PLAN REVIEW SHEET

2016-134

Southminster, Inc.

Bus stop pad detail

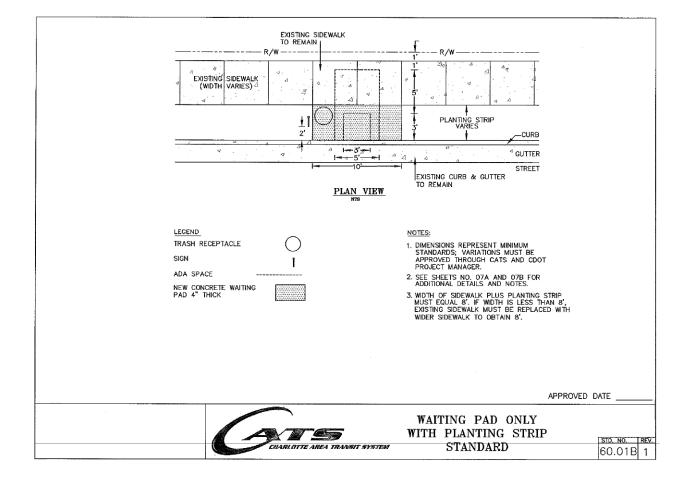
This site is located on an existing bus route. The Petitioner is requested to provide and construct a new waiting pad for a relocated bus stop on Ashley Road. The recommended new location is within the proposed new planting strip on Ashley Road, at least fifty feet south of the proposed driveway, so that a stopped bus will not block the driveway.

Below is an image of the standard detail (60.01B) for the requested bus stop pad. Permanent easement is requested, where dimensions exceed existing or proposed right-of-way limits.
